STAFF MEMORANDUM

Subject: SP2021-20 Ronald and Loreen Racicot, 21 Old Wilton Road, Tax Map 14 Lot 10. Public Hearing for a major site plan application to construct a 4,500 sf. warehouse and storage building and associated site improvements within the Industrial District.

RE: Ronald L. & Loreen M. Racicot. – Subdivision & Site Plan
Tax Map Parcel 14-10, 21 Old Wilton Road
(Response Letter to Staff Memo, 9-1-21 Review Comments)

SITE LAYOUT PLAN

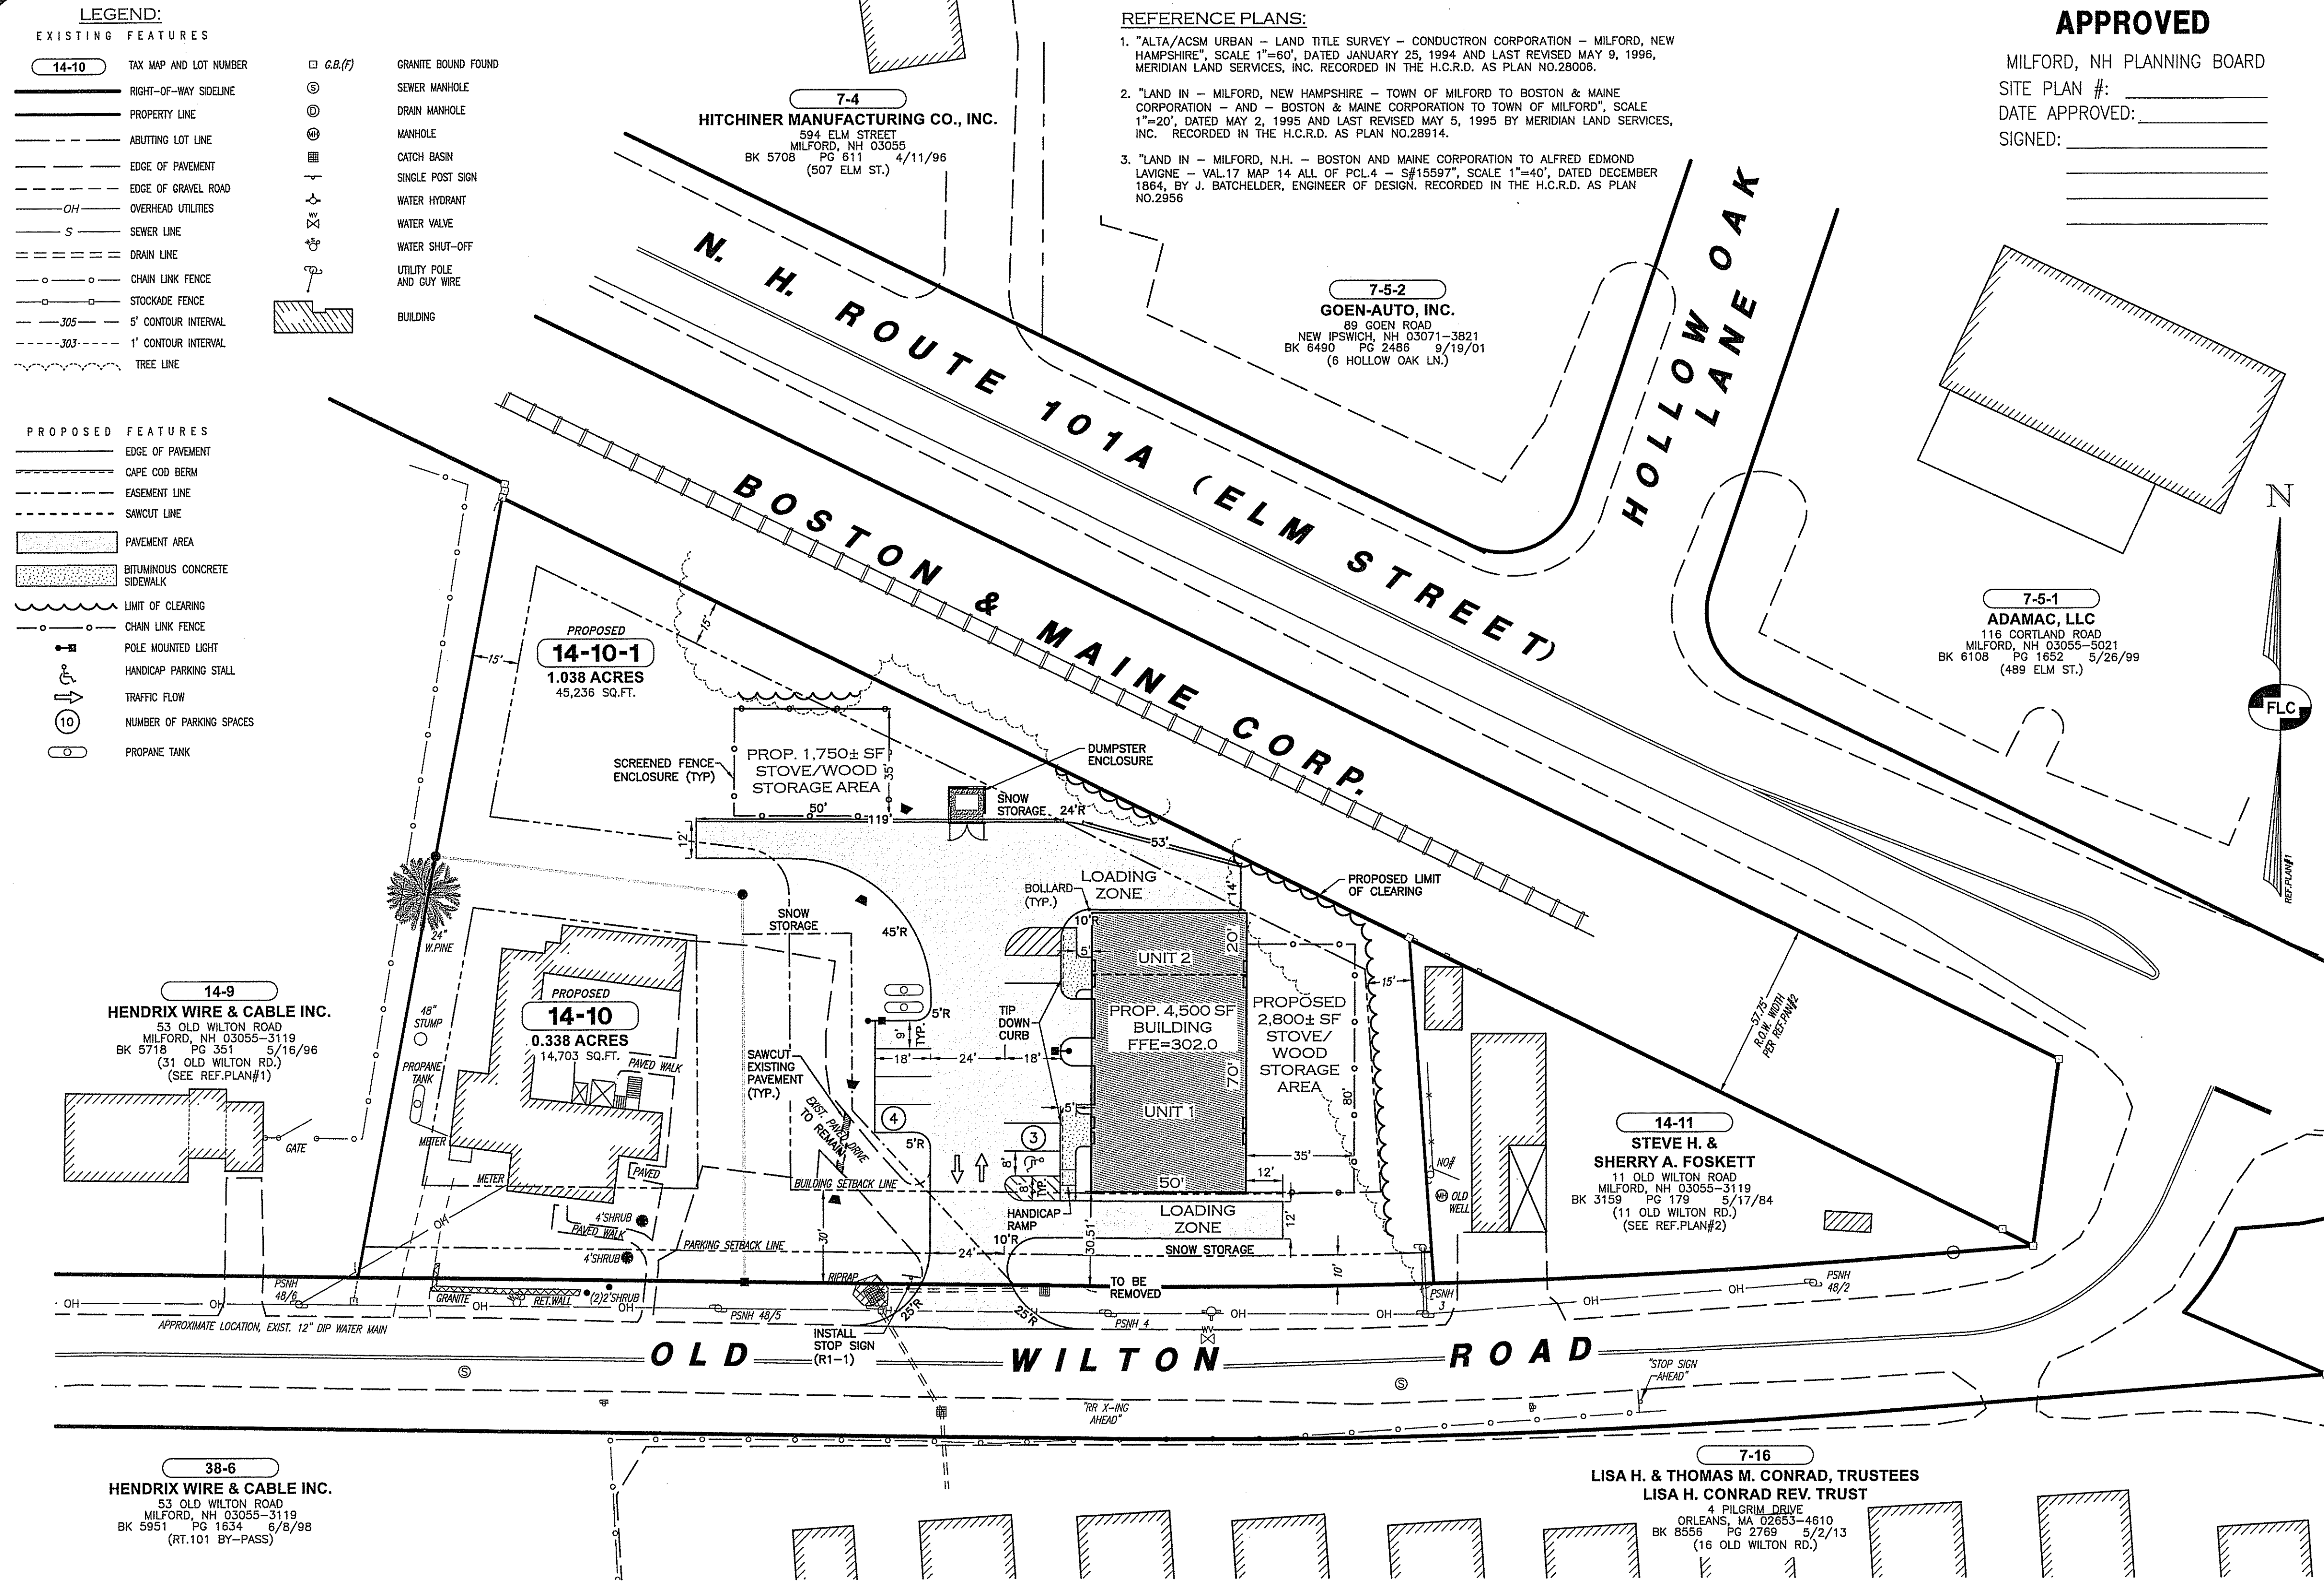
11. On sheet 3 of 9, please add the words "and shielded" after the word downcast in note F.

12. On sheet 3 of 9, please add a label for the propane tanks.

The addition of "and shielded" has been included in note F on sheet SP-1 regarding lighting.

The proposed legend on sheets SP-1 and GR-1 includes a propane tank symbol. The propane tanks are called out on the Grading and Utility plan (GR-1).

LANDSCAPING PLAN
INDUSTRIAL DEVELOPMENT
 TAX MAP PARCEL 14-10 - 21 OLD WILTON ROAD
 MILFORD, NEW HAMPSHIRE
 PREPARED FOR AND LAND OF:
RONALD L. & LOREEN M. RACICOT
 70 PUTNUM HILL ROAD, LYNDEBOROUGH, NH 03082-6134.

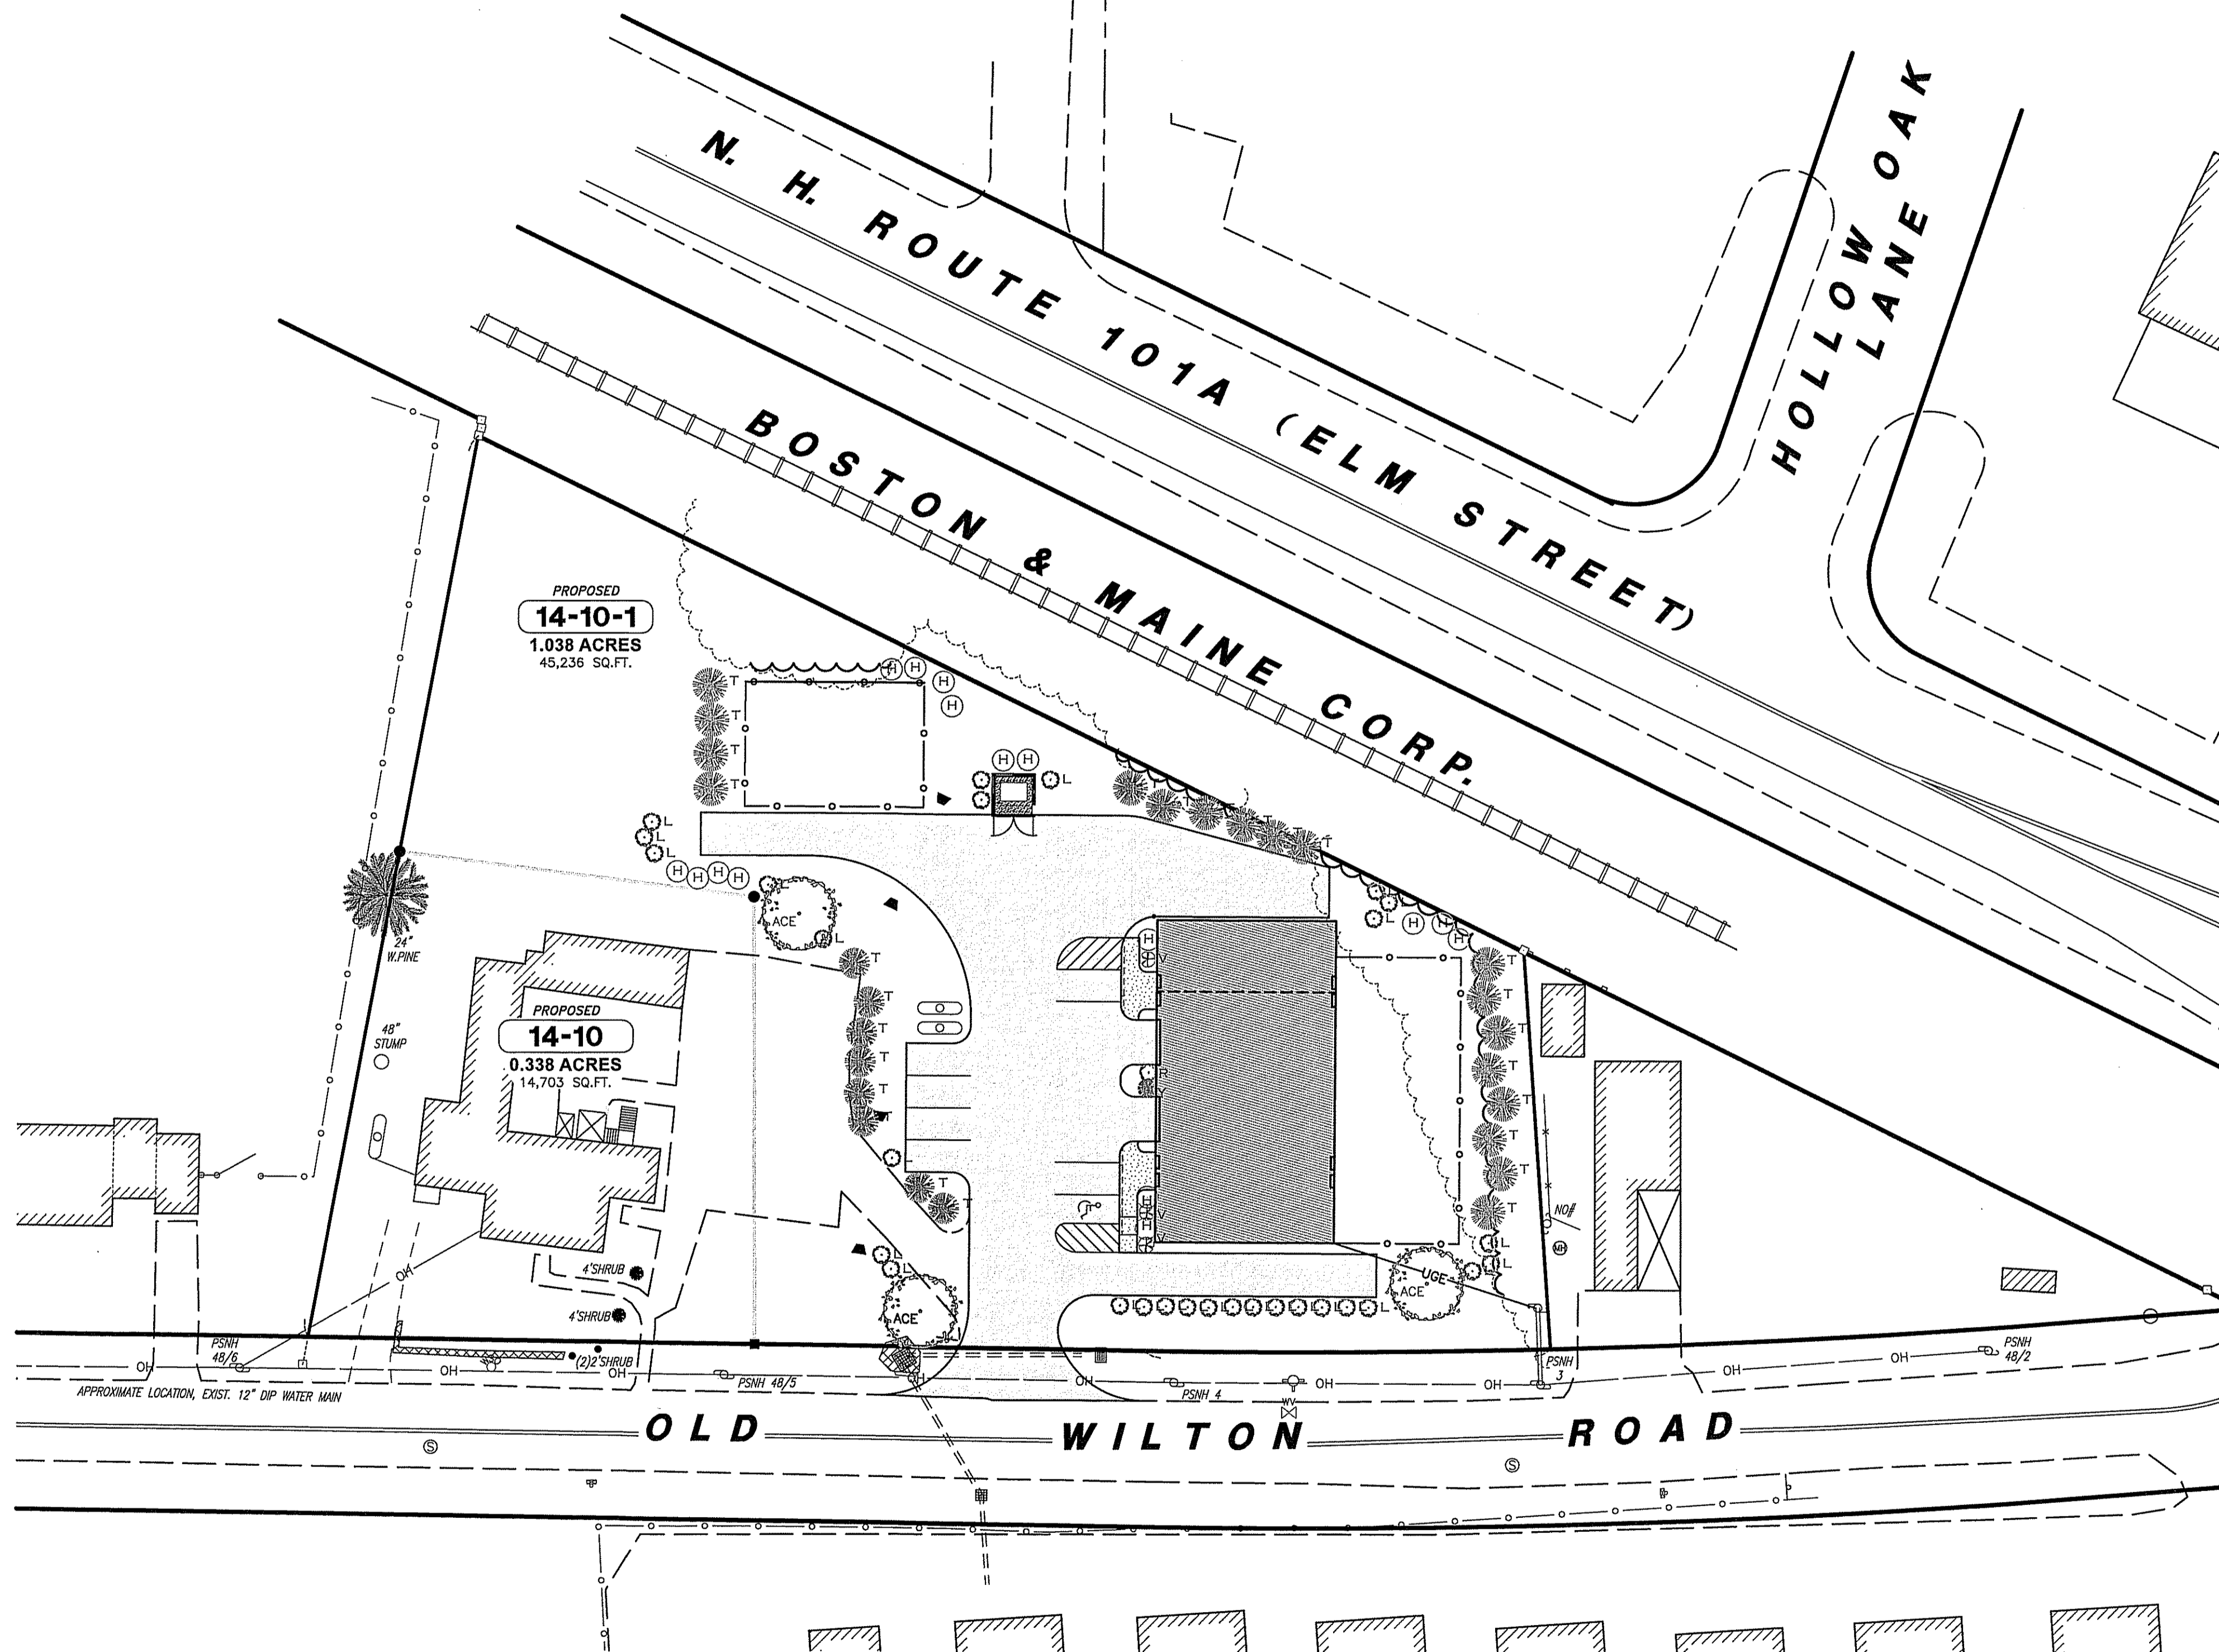
4. Consider staggering the arborvitae along the eastern border as opposed to a long linear line. **The arborvitae have been staggered to provide a more natural looking landscape screen.**

5. Extend the landscaping to fully screen the site from the new lot. **Additional plantings including a shade tree and lilac bushes (or equal) are proposed to fully screen the site from the new lot.**

STORMWATER BASIN OUTLET STRUCTURE OS1

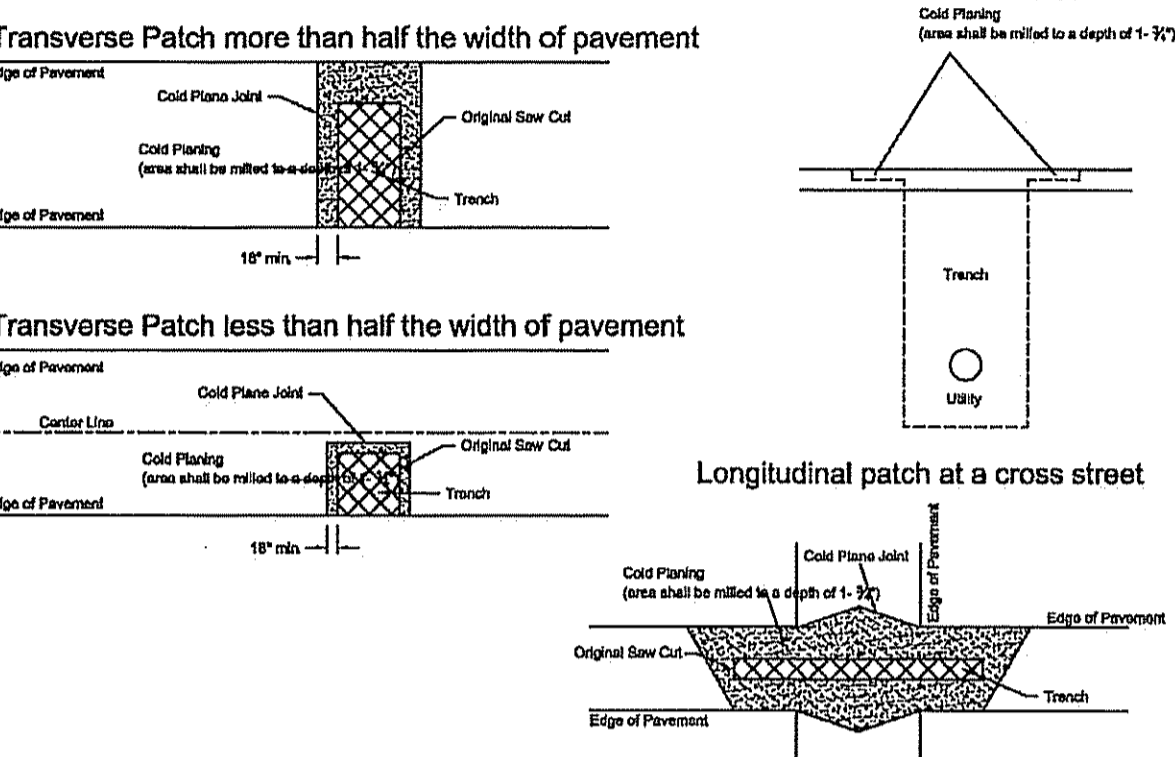
1. As previously noted, portions of the proposed stormwater ponds and the outlet structures are located within the Town right-of-way (appears that the ponds were revised but not the outlet structures). All stormwater mitigation improvements, except pipe connections to the Town's drainage system, must be located on private property, not in the Town's right-of-way unless otherwise permitted by the Town. The applicant's engineer indicated that this arrangement was allowed by "all parties" if no

new structures were proposed within the right-of-way. The current plans show there are two new outlet structures within the right-of-way which sets a problematic precedent, in my opinion. Plan revisions are required unless the outlet structures are permitted to be installed on public property by the Town.

1. Portions of the stormwater ponds and the outlet structures are located within the Town right of way. All stormwater mitigation improvements, except connections to the Town's drainage system, must be located on private property, not in the Town's right-of-way. Revisions are required.
The outlet structures are installed on an existing driveway culvert that is already encroaching on the town's right-of-way. In order to minimize impact in the right-of-way and maintain existing drainage patterns, we propose to use this existing culvert. The stormwater basins been revised to not encroach in the Town's right-of-way. This concern was raised in the past and all parties agreed that the drainage could remain as long as no new structures were proposed in the right-of-way.
